4.D Noise

Case No. 2018-007883ENV 4.D-1 Balboa Reservoir Project March 2020 Responses to Comments

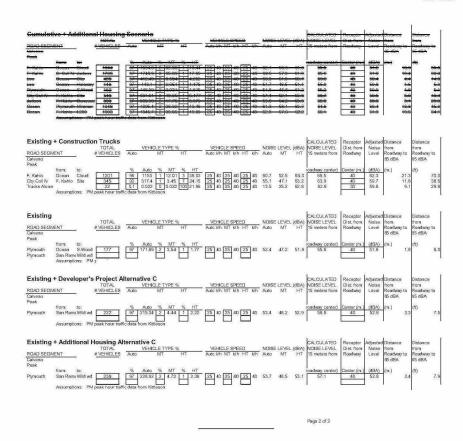
"In addition, some of the testing reports appear to provide inconsistent testing. This makes it difficult for non-professionals to compare apples to apples, track the meaning of the data and encourages misinterpreting possibly impactful conclusions. For example, adding a note below the Balboa Reservoir truck Roadway Noise Analysis on Page 1of 2, in Appendix D2, would provide clarification of why the numbers of road segments tested differ depending on whether the test is for the existing environment, the existing plus developer's project, the existing plus additional housing scenario, or the cumulative plus developer's project."

The commenter requests clarification regarding the difference in the number of roadway segments analyzed in the traffic modeling spreadsheets between the various scenarios in Appendix D2 of the draft SEIR.

Page 1 of Appendix D2 of the draft SEIR contains the inputs and results for the roadway noise analysis. Operational traffic noise impacts are addressed on draft SEIR pp. 3.C-36 through 3.C-38 while the cumulative traffic noise impacts are addressed on draft SEIR pp. 3.C-40 through 3.C-41. The differences in the number of roadway segments analyzed depends on several factors, including whether sensitive receptors are present along a given roadway and whether the extent of traffic distribution warrants an analysis of a roadway segment. Draft SEIR p. 3.C-36 states that "[n]oise modeling was completed to estimate existing (baseline) and future (with the proposed project) traffic noise levels along seven street segments that have sensitive receptors in the project area based on traffic volumes presented in SEIR Section 3.B, Transportation and Circulation." The seven road segments are shown on Table 3.C-11 on draft SEIR p. 3.C-37.

Initially, two segments of Ocean Avenue extending in either direction from the access point were included in the analysis. These two roadway segments were included in an initial draft of the analysis but were removed because existing roadway noise rendered the project contribution negligible. The traffic model spreadsheet inadvertently retained rows for the two Ocean Avenue segments in the appendix even though the analysis for this roadway were not included in the draft SEIR. Pages 1 and 2 of draft SEIR Appendix D2 have been revised to reflect the deletion of these roadway segments from the analysis.

Therefore, cumulative line items have been deleted from Appendix D2 as shown below and are not cited in the draft SEIR. The appendices serve as supporting information to the draft SEIR and the relevant data and analysis are presented in the draft SEIR; therefore, additional clarification within the appendices is not necessary. The clarifications to the appendices have been shown below (deleted text is shown in strikethrough and new text is shown in double underline). These changes do not result in significant new information with respect to the proposed project, including the level of significance of project impacts or any new significant impacts.
